INNER WEST COUNCIL

DEVELOPMENT ASSESSMENT REPORT

Application No.	D/2018/431
Address	8 Broderick Street, BALMAIN NSW 2041
Proposal	Removal of a Quercus Robur (English Oak) located in the rear yard of heritage listed property.
Date of Lodgement	16 August 2018
Applicant	C Fox Johnston
Owner	Mr C G T Johnston and Mrs K G Johnston
Number of Submissions	One
Value of works	\$1,000.00
Reason for determination at Planning Panel	Partial demolition of heritage item (tree removal only)
Main Issues	Heritage; Tree Removal
Recommendation	Approval

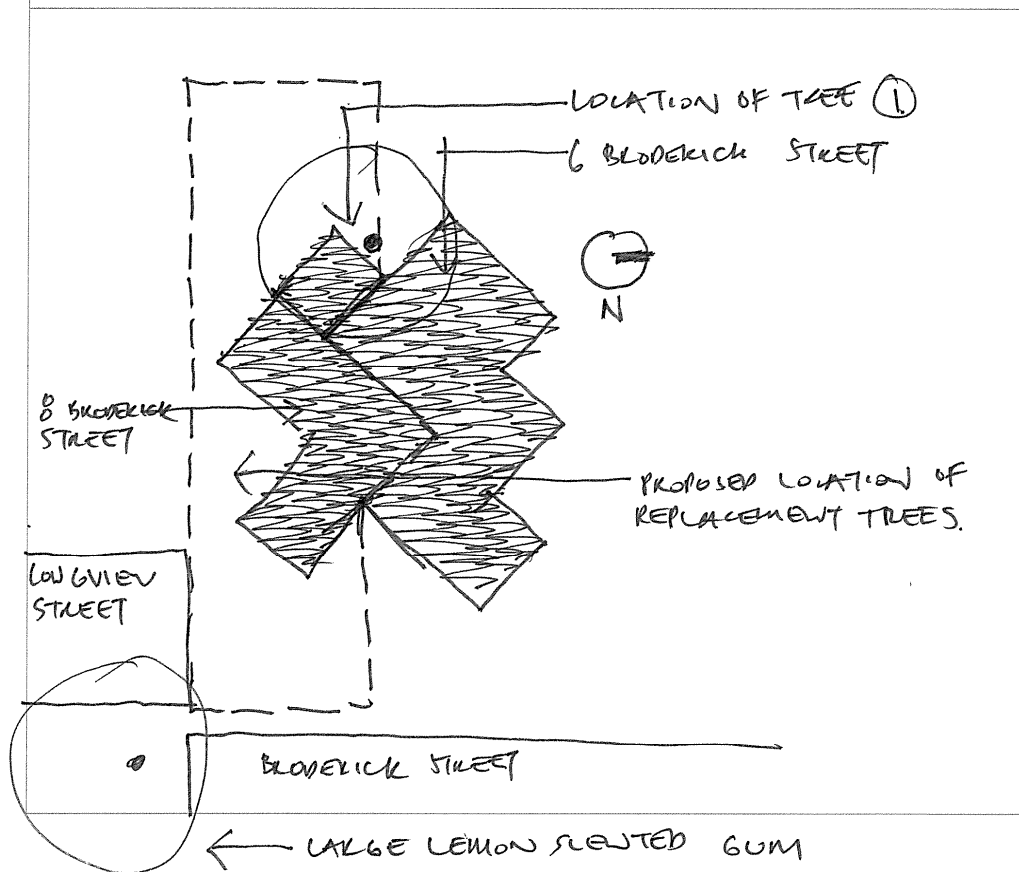
Is Replacement Planting proposed:	
<input checked="" type="checkbox"/> Yes – Please specify:	2 x 75LT TREES IN LOCATION SHOWN ON THE ATTACHED DIAGRAM .
<input type="checkbox"/> No – Please specify:

The applicant has proposed two x 75L replacement trees. Council's Tree Assessment Officer has recommended that replacement planting with one native tree attaining a minimum height of 8m upon maturity is sufficient to offset the loss of canopy cover and landscape amenity. This replacement tree, combined with retention of the remaining garden plants, will create a positive contribution to the surrounding landscape and enhance the visual appeal of the neighbourhood.

Tree/species	Quantity	Location
Native specimen capable of attaining a minimum mature height of 8m upon maturity	1	Suitable location on site
